John A. Green's Sketch
& Explanation
Filed June 25, 1898.

"D1" Dickens Co.

Dickens, Texas, June 21st 1898

A Section of the Eastern part of Wichita Co. Texas

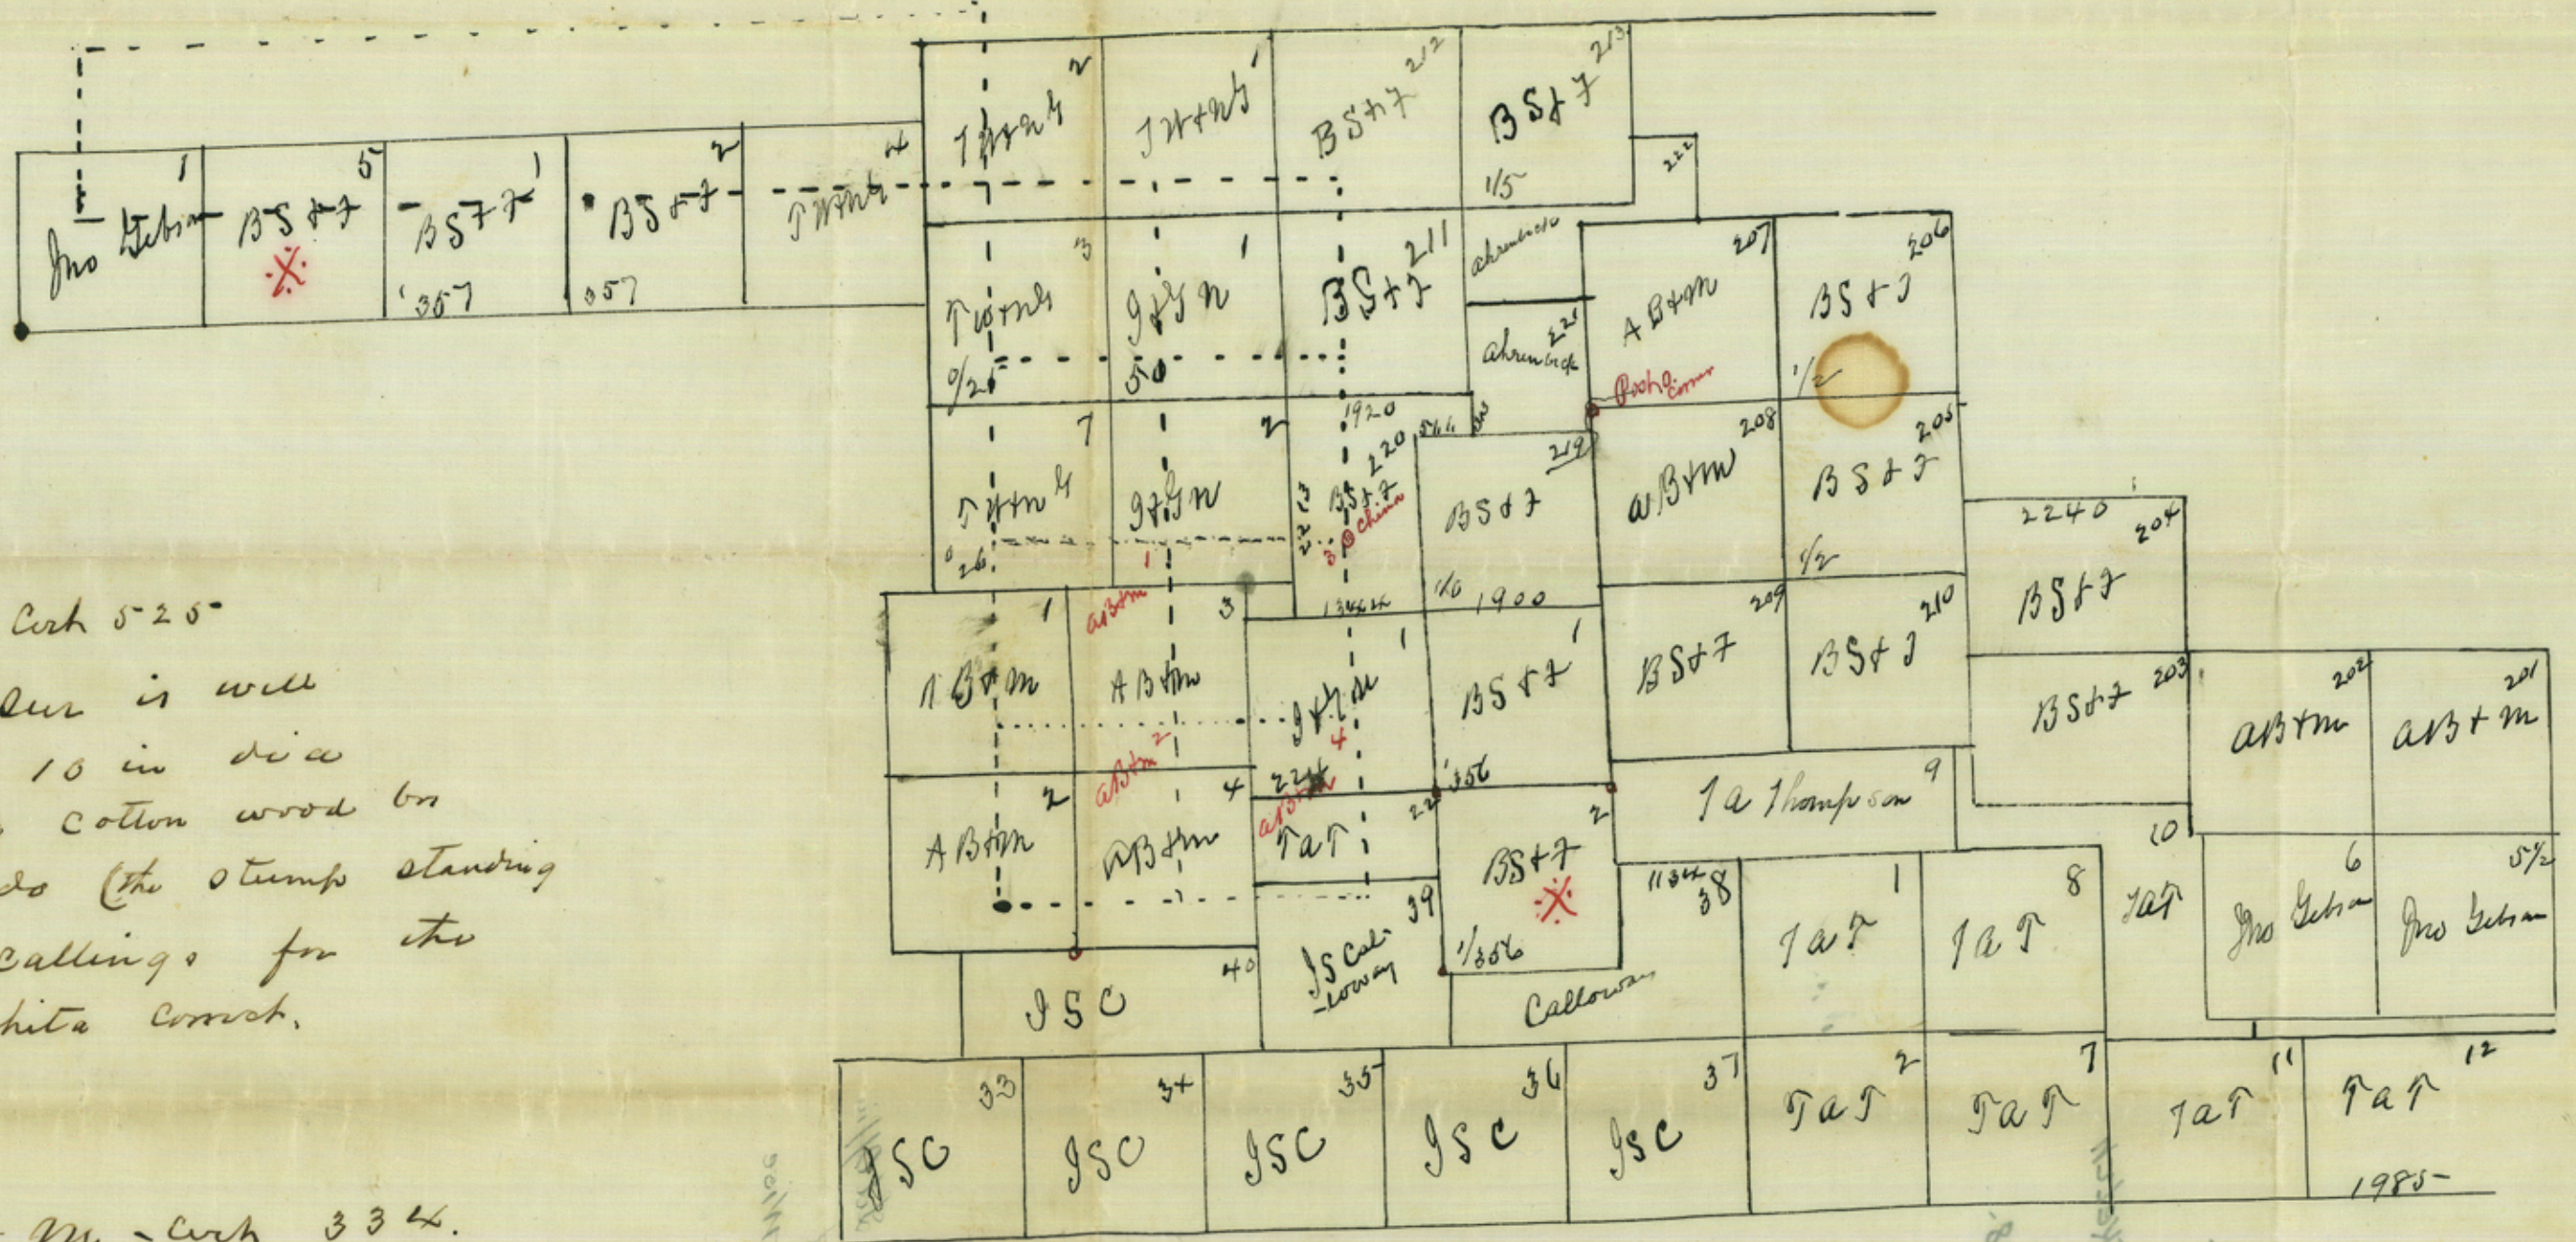
I had occasion some time ago to do some work in the Eastern part of this County. And find some conflicting work there, which I have concluded to submit to you for instructions. 1st The S W Cor of sec no 207. Cont 525. seems to be a noted corner. from which several of the former Dist surveyors ran their base line to Abbie Pt. (to the west) this cor is on the ground. & well defined. The enclosed plat is made from this corner. The dotted lines will show where the conflict comes in on the ground. The

N.E. Corner of of sec No 3. A.B. &
M. Cert 534 calls for a Hackberry bearing
I find this Hackberry as running
from the P. oak Cr. in Sec 220. B.S. & F
and from this corner, 1900 on west and
3800 south for the S.W. Cor of sec
No 4 which calls for a cotton wood
8 in in dia. we found on a high
naked hill - in the near distance of
which no cotton wood could we have
grown. Mr Merwood our late surveyor
adopted this Cor. showing the land
on the ground both East & North -
but from which I can find no land
marks as called for in the original
field notes. I also find that 220
B.S. & F is an older sur than no 3
A.B.M. Will you instruct me which

of these works your office recognizes
as the true and original work.
It is true that China Tree on the N.E.
Cor of sec No 3- seems to be all right
but the S. Pt of No 4. will be missing
and it is equally true that No 3- begins
on No 1. and No 1. calls to begin on
on the East line of the Elizabeth King
sur. whilst in fact it lays some
6 miles eastward. Some surveyors run
from one of these corners and some
from the other creates great confusion
wherefore I ask to be advised by the
Land office in the premises.

It is shown by this sketch + statement, and also
by W R Norwoods sketch in 1894, that the
SW cor of No 207 AB + No 7 NE cor of No 3
AB + No (S-10679) have been identified and,
that the sd NE cor of No 3 is inside of
Sur No 220 B S + T (S-10191) an older
sur. This position of No 3 to No 207 has been
recognized, as the present map of the County shows.
This statement that a cottonwood tree 4 in dia
S 40 E 78 70 was looked for 7 mile West + 2 miles
South from NE cor of No 3, shows that the Sur-
veyor's record of notes of No 4, does not
agree with notes of No 4 on file here. The
field notes here, call for said Cottonwood
at the "SE" + not at the "SW" cor of said
Section. Where corners can be identified on the
ground, they will hold the surveys over ^{other} calls.
